PARTS LIST FOR MODEL SLAMMER III 3500
Model # SLA3500 (aka SLAiii3500)

MRP Ver 010120
(based on Penn's Rev. 1 07-01-17)

Penn Reel Parts list for Model: SLA3500 (SLAiii3500) SLAMMER iii SPINNING

ORIGINAL BAIL SETUP
With different bail, roller etc.
Bushing only version

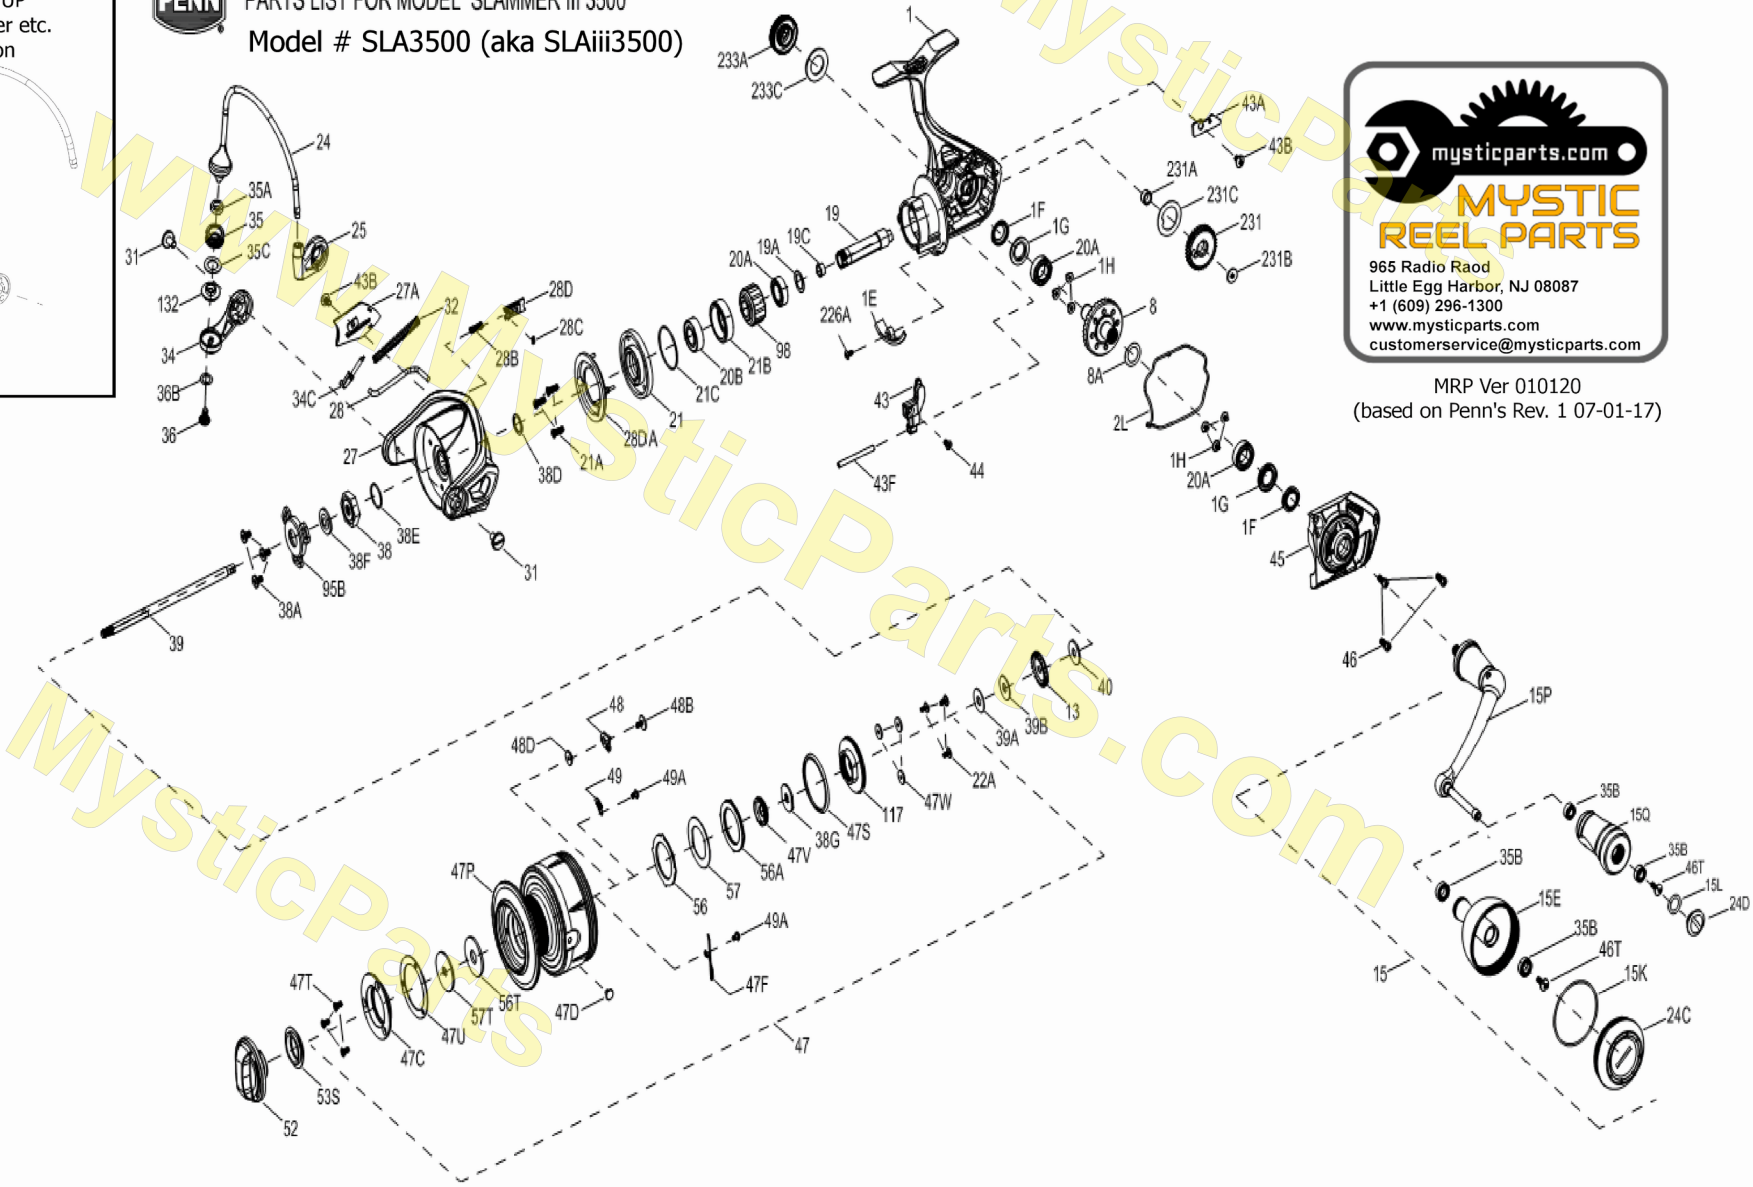
BAIL WIRE, LINE ROLLER PARTS CHANGED FOR REV 1**ORIGINAL W/JUST BUSHINGS**

NEWER W/BALL BEARING/BUSHING COMBO

NO 132A ON THE NEWER SETUP

39B AND 40 ON THE SLA3500 AND SLA4500 REELS WERE IN REVERSED POSITIONS

THE 39B METAL WASHER WAS FOUND BELOW THE 13 RATCHET ON THE SHAFT INSTEAD OF ABOVE IT

39A THERE MAY BE MORE OF THESE PLASTIC SHIM WASHERS THAN SHOWN ON THE DIAGRAM

POSITIONING MAY ALSO BE ALTERED AS THEY SHIM IT TO GET THE SPOOL TO A SPECIFIC POSITION ON THE SHAFT

24	1418983	24-SLA3500	BAIL WIRE
35	1276939	35-SSV3500	LINE ROLLER
35A	1418992	35A-SLA3500	LINE ROLLER BUSHING
132	1277096	132-SSV5500	LINE ROLLER COLLAR
132A	1277097	132A-SSV5500	LINE ROLLER WASHER
36	1277061	36-SSV5500	LINE ROLLER SCREW
36B	1417809	36B-CLA6000	BAIL ARM SCREW WASHER (OLD 36B-CLA5000)
25	1385539	25-CLA3000	BAIL HOLDER

24	1474153	24-SLAiii3500	BAIL WIRE
35	1474154	35-SLAiii3500	LINE ROLLER
35A	1474155	35A-SLAiii3500	LINE ROLLER BUSHING
35C	1385552	35A-CLA3000	LINE ROLLER BALL BEARING
132	1474156	132-SLAiii3500	LINE ROLLER COLLAR
